Huoltotiedote / Service Info / Servicemeddelande

Valtra ** - 228 0159 10 - 230/280 TGU6

Uudistunut malli / New design / Ny design

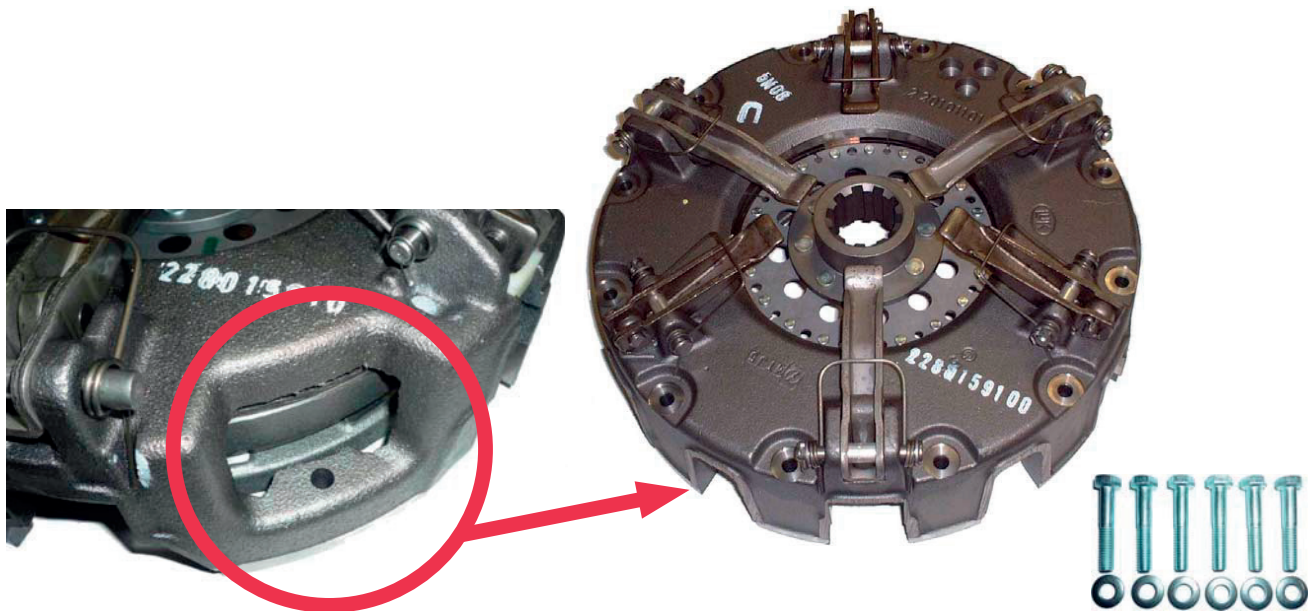
EN This new design utilises the latest clutch technology, using a vented housing for improved cooling and heat dispersal.

Fully interchangeable with existing clutches with no modifications required to vehicle or flywheel.

New fixation bolt set 6 x M8 x 1.25 x 50mm is supplied with new designs to accommodate the lower housing.
